PROJECT: Webster University - Interdisciplinary Science Building
ENGINEER: Cannon Design
DESCRIPTION: Linear Slot Supply, 1" Slot
SDS100//I/48.000/4/14//I/ZZ//B12

Shop Drawing Submittal Review

Project Name: Webster University-**ISB**

Copies	No.	Description
1 PDF	238800M08	(Submittal No.'s:) (R&B-CxSRC)
		(Cannon #238800-11) - (Paric #15051-0370) - (WES #607)
		➤ Air Distribution – Price Air Devices

SDS100 1" Slot Linear Supply

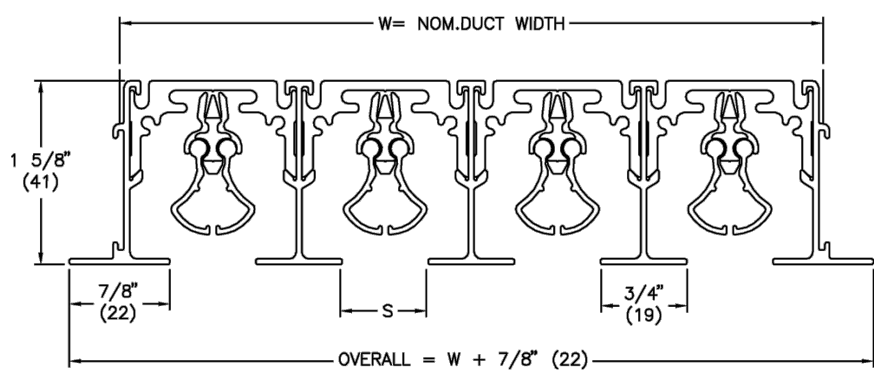
1. Confirm device quantities.
2. Verify ceiling construction with frame types.
